HISTORIC AND DESIGN REVIEW COMMISSION

HDRC CASE NO: 2022-428
ADDRESS: 1614 E HOUSTON ST
LEGAL DESCRIPTION: NCB 577 BLK 16 LOT 5
ZONING: RM-4, H
CITY COUNCIL DIST.: 2
DISTRICT: Dignowity Hill Historic District
APPLICANT: William Brewer/Done Right Construction DBA
OWNER: GOFORTH DERETHA & PATRICIA SCOTT
TYPE OF WORK: New construction of a 1.5-story, single-family structure
APPLICATION RECEIVED: February 27, 2023
60-DAY REVIEW: Not applicable due to City Council Emergency Orders
CASE MANAGER: Claudia Espinosa

The applicant is requesting conceptual approval to construct a 1.5-story, single-family structure.

Exterior Elevations

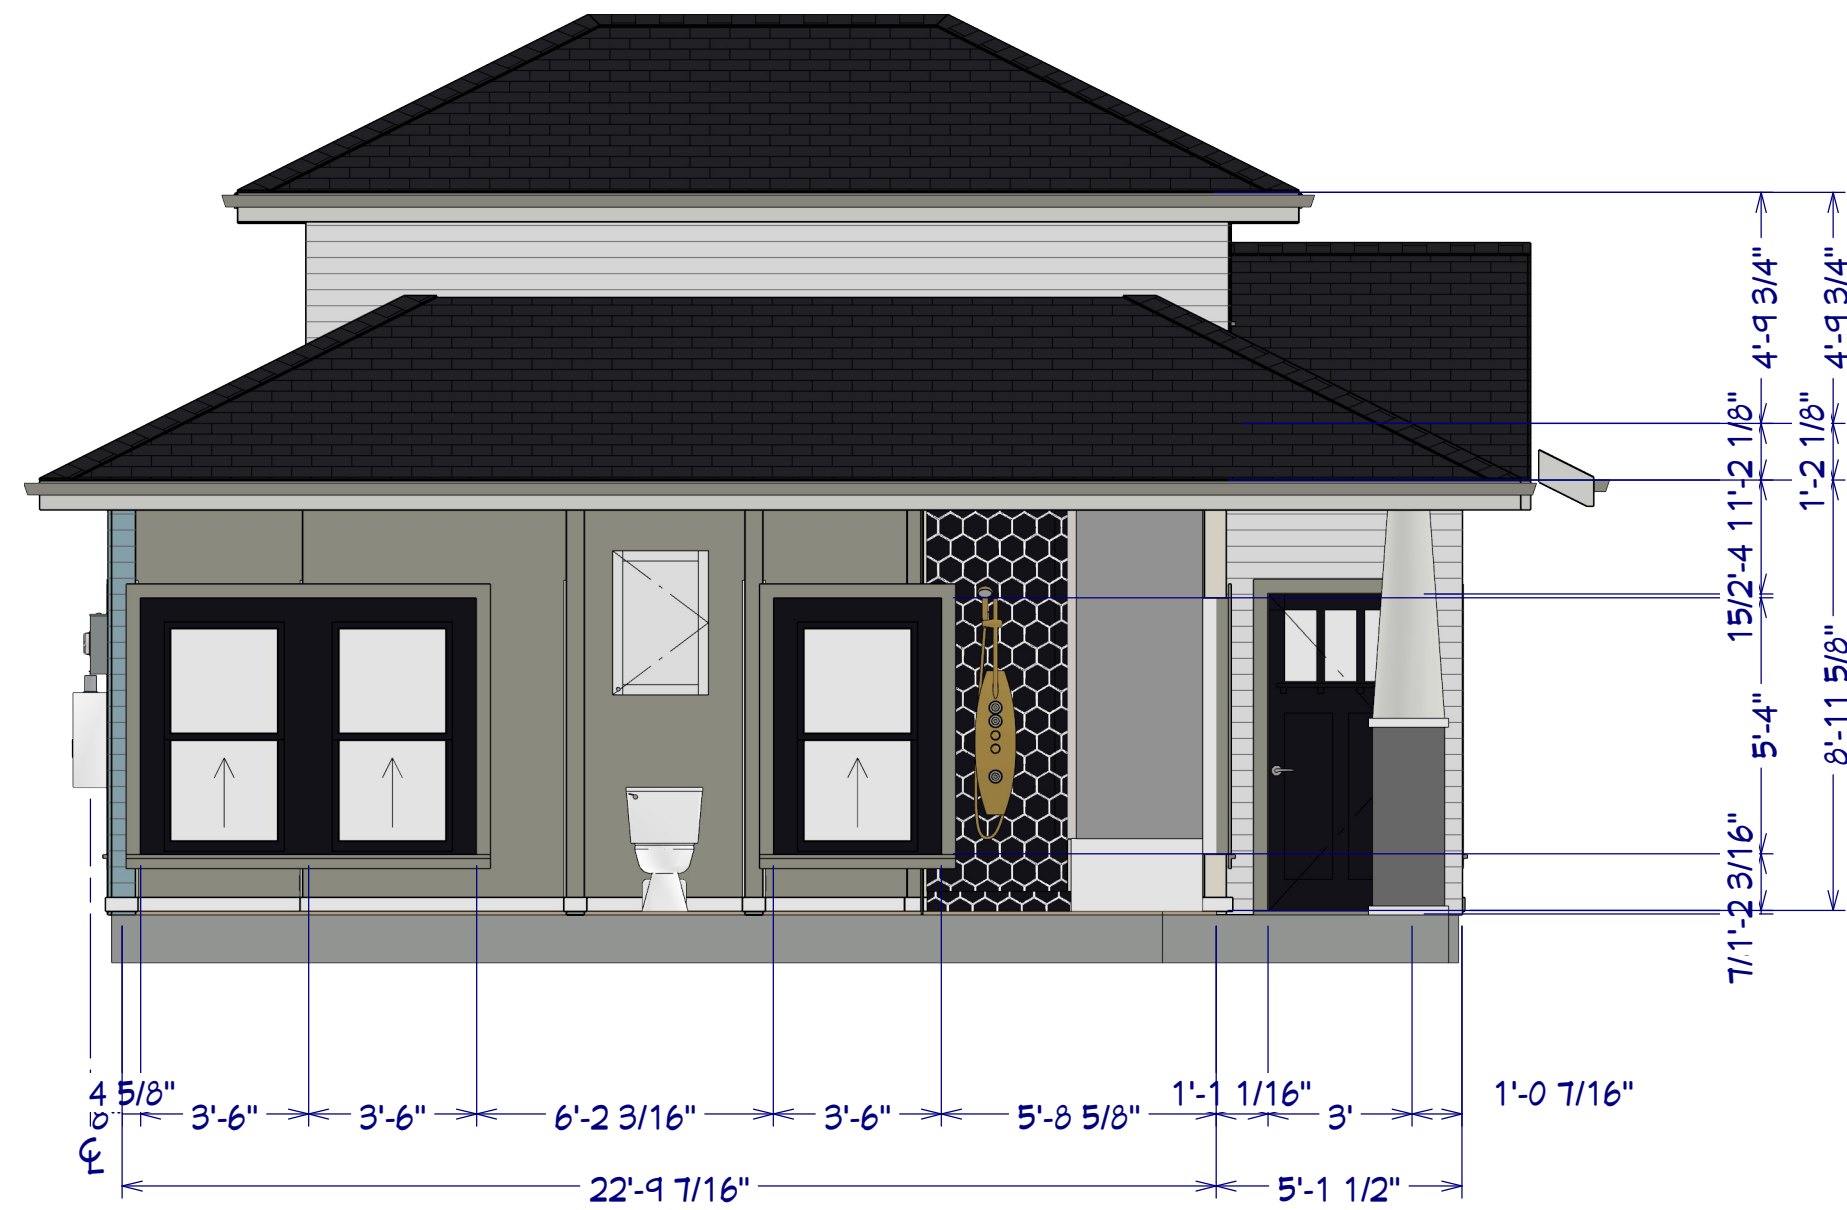
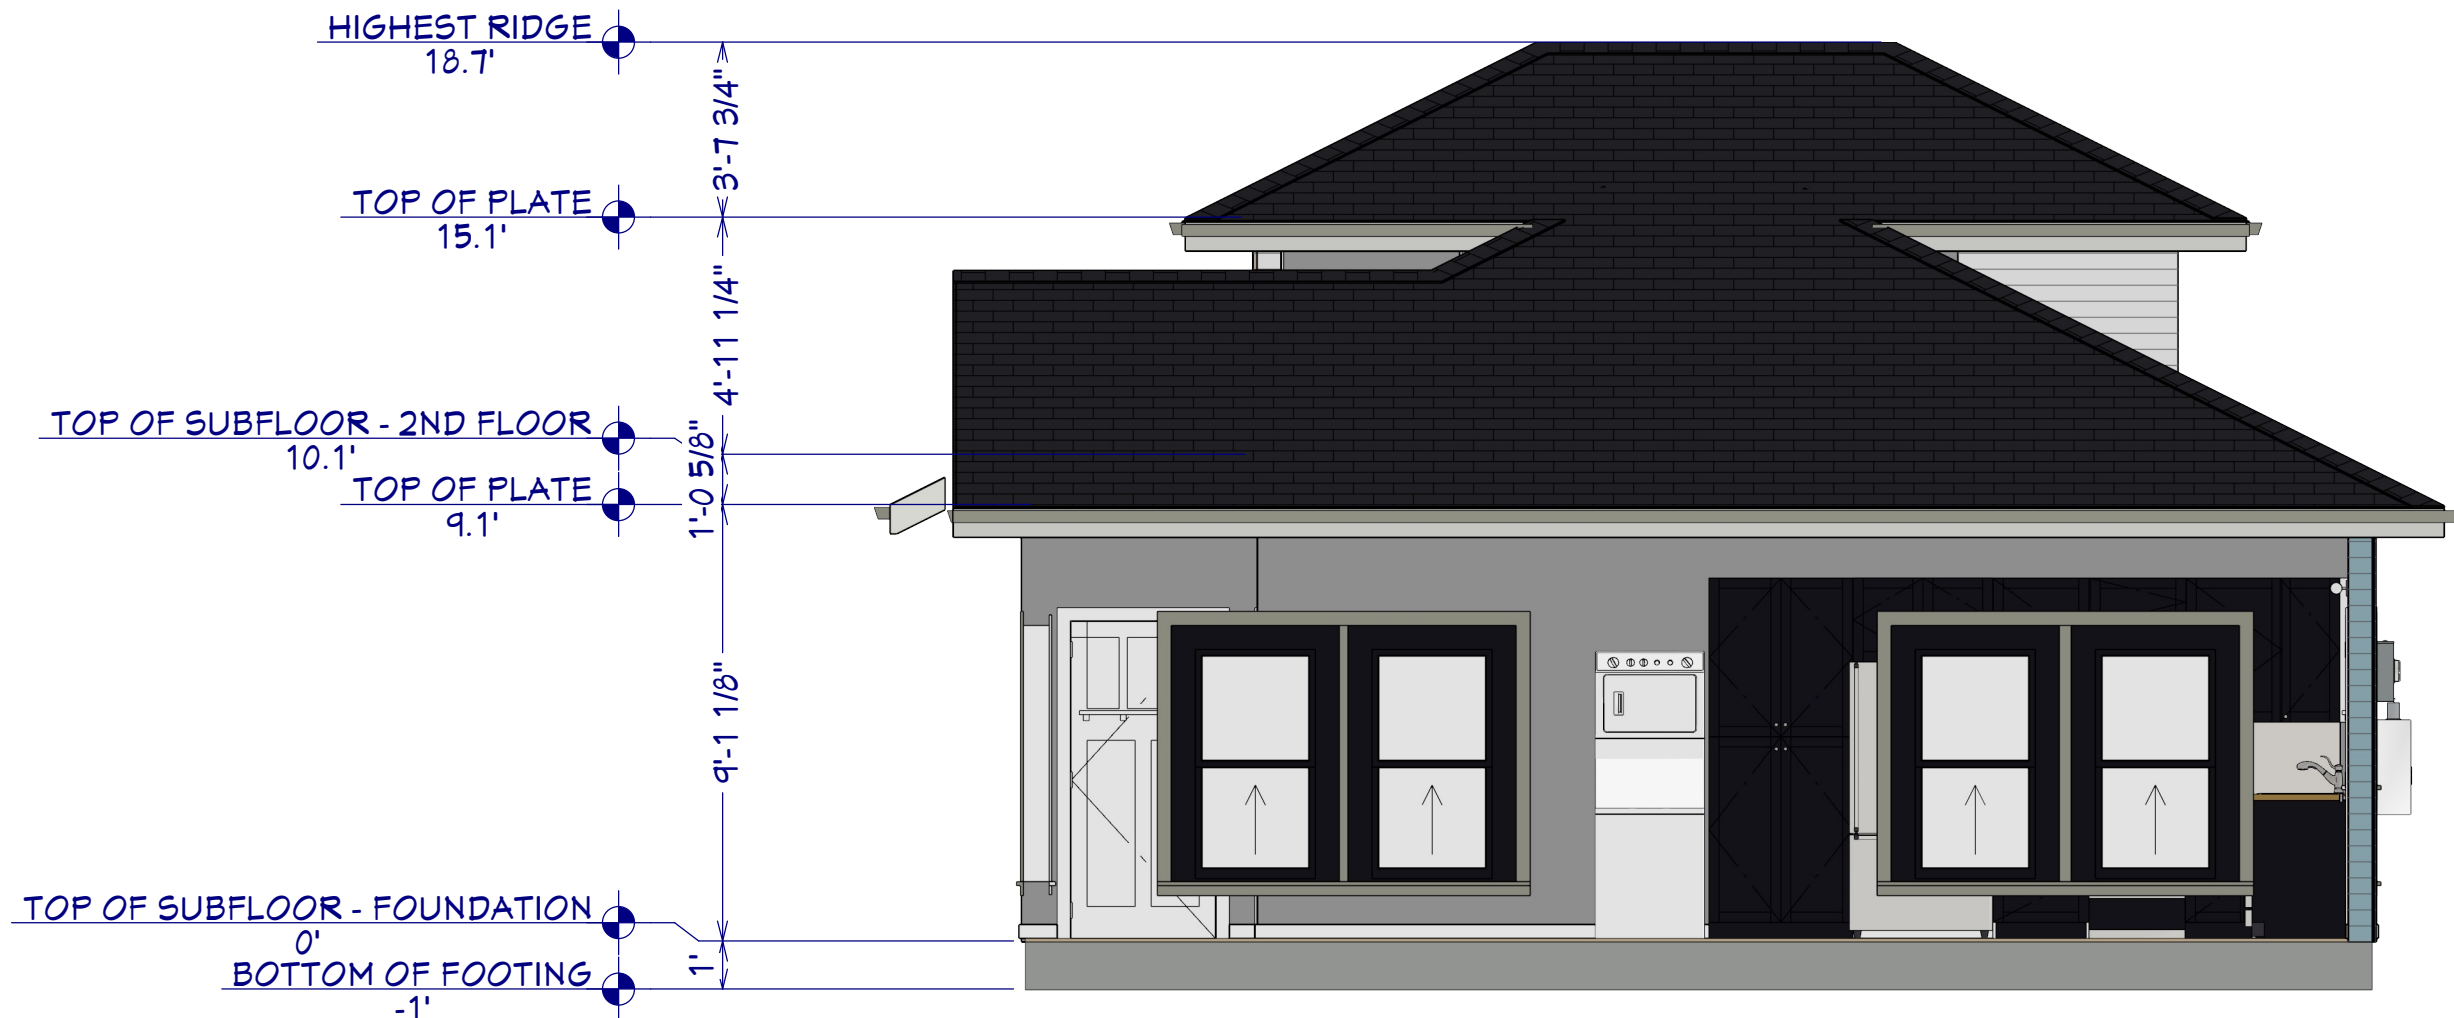
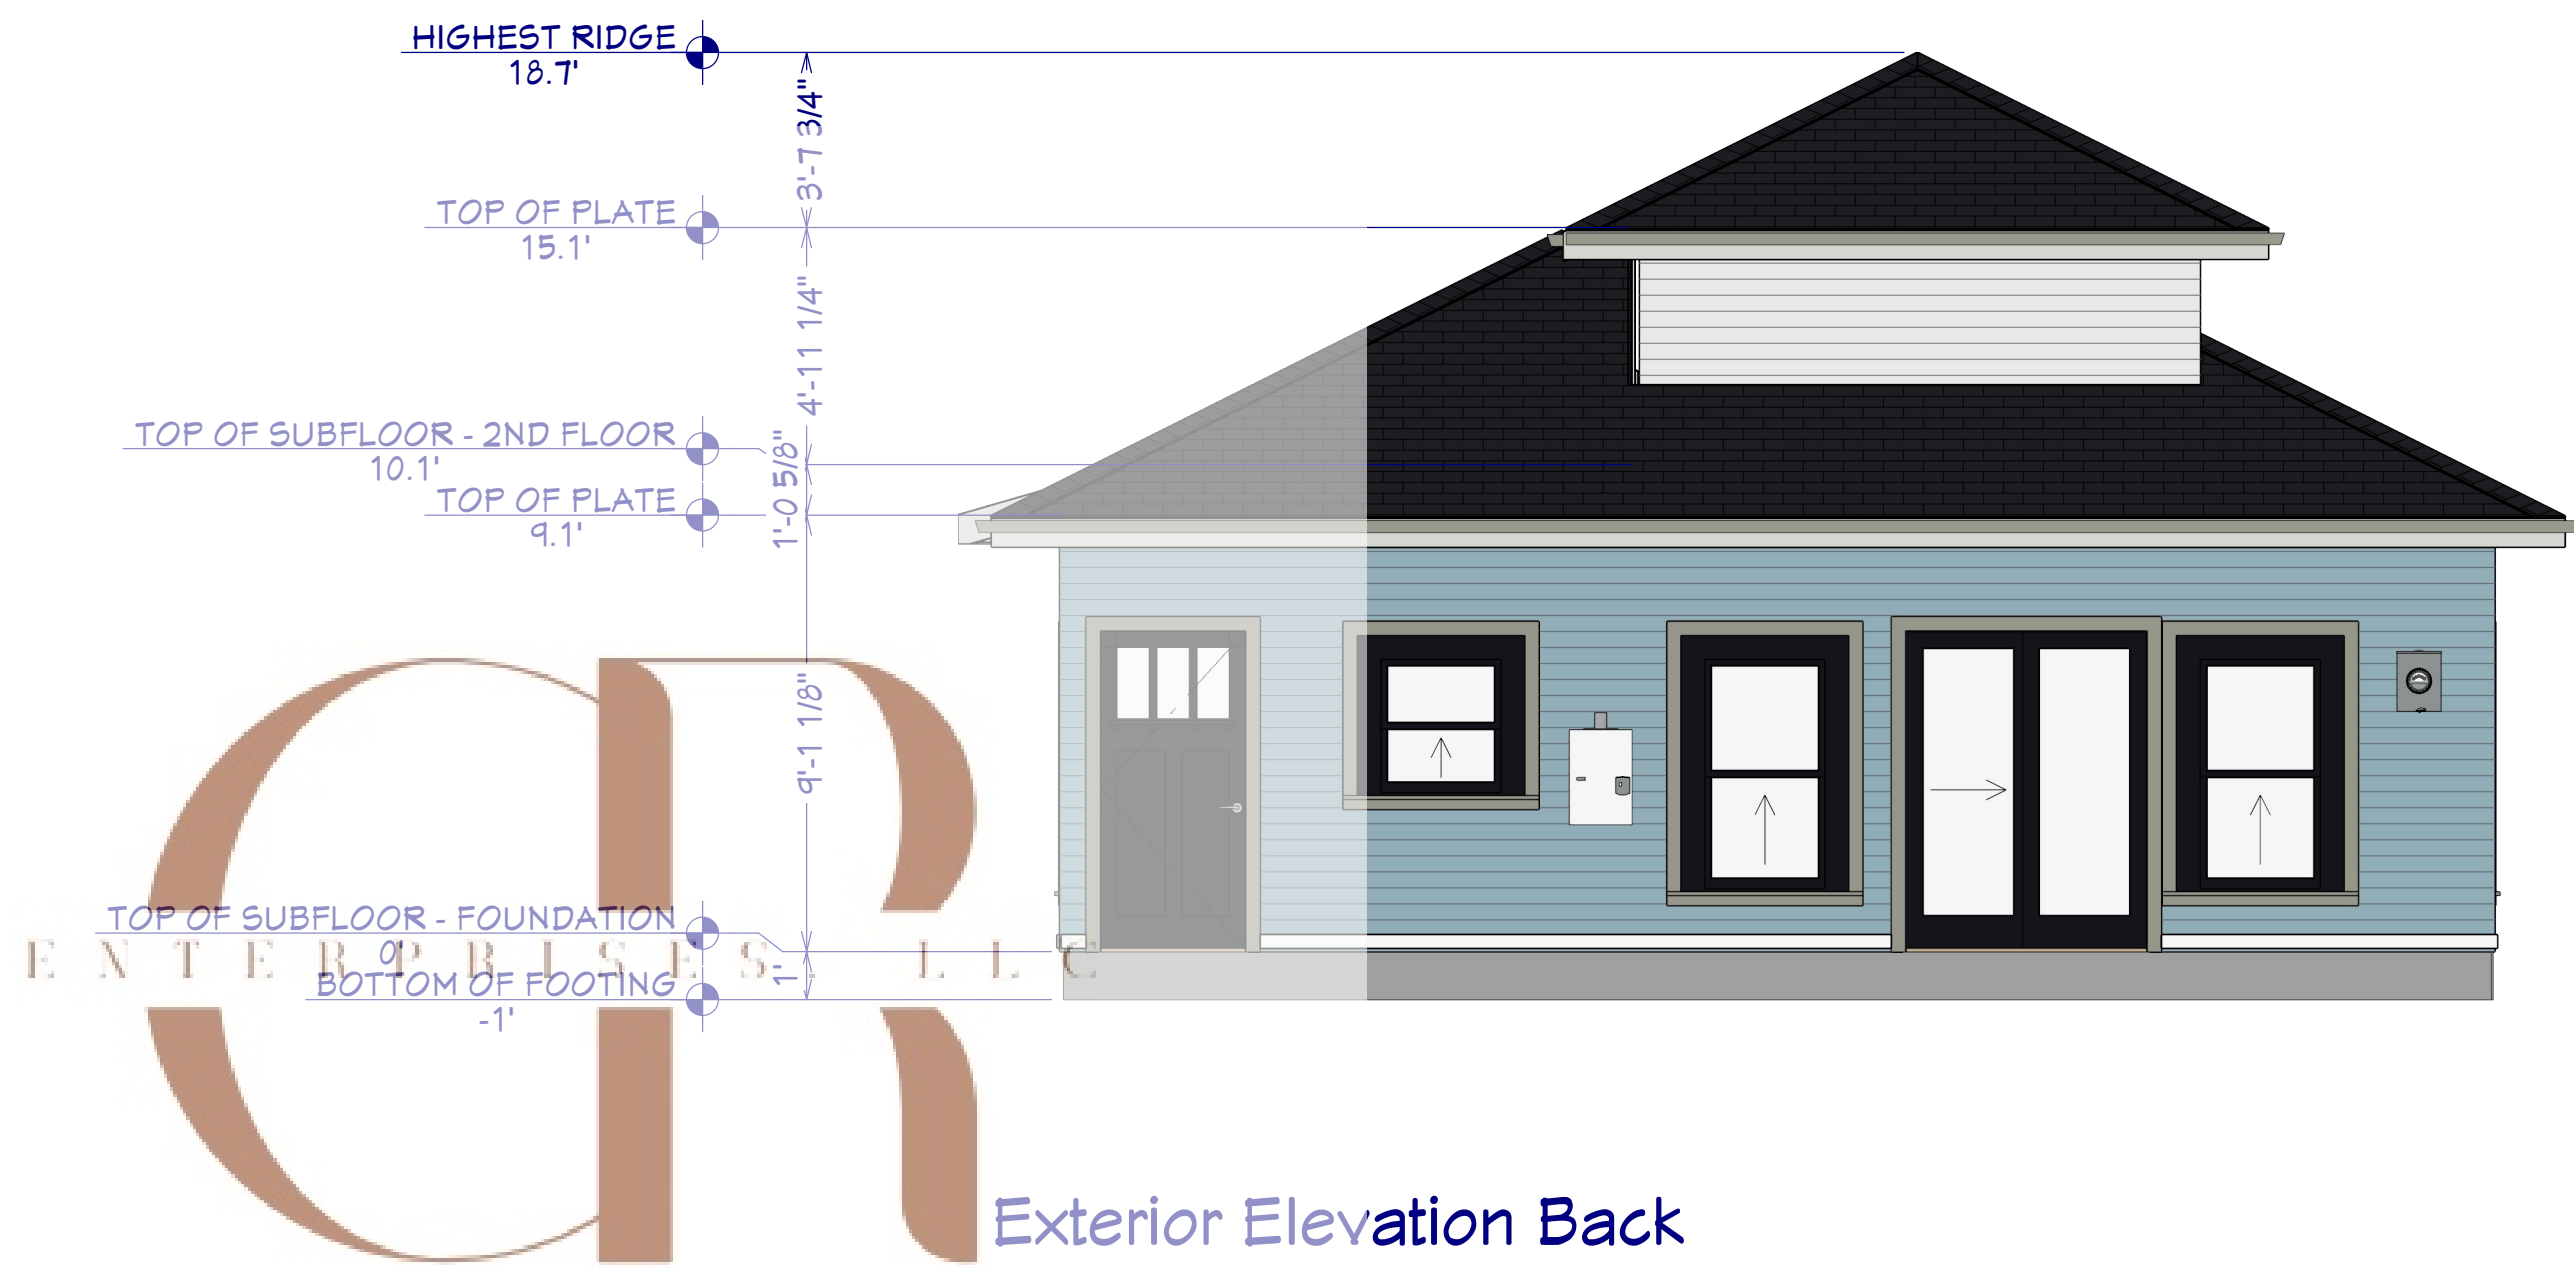
- g. **SCALE & MASS** – The applicant has proposed to construct an approximately 980-square-foot 1.5-story residential structure. According to Guideline 2.A.i for New Construction, new structures should feature a height and massing that is similar to historic structures in the vicinity. In residential districts, the height and scale of new construction should not exceed that of the majority of historic buildings by more than one story. This block within the Dignowity Hill Historic District features 1-story historic structures. Staff finds that the proposed scale and massing of the structure appears generally appropriate.

- i. **ROOF (FORM)** – The applicant has proposed a hipped roof form with a dormer for the proposed new construction. According to Guideline 2.B.i for New Construction, new construction should feature roof forms that are consistent with those predominantly found on the block. Staff finds this request is reflective of the Dignowity Hill Historic District and is consistent with the guidelines.
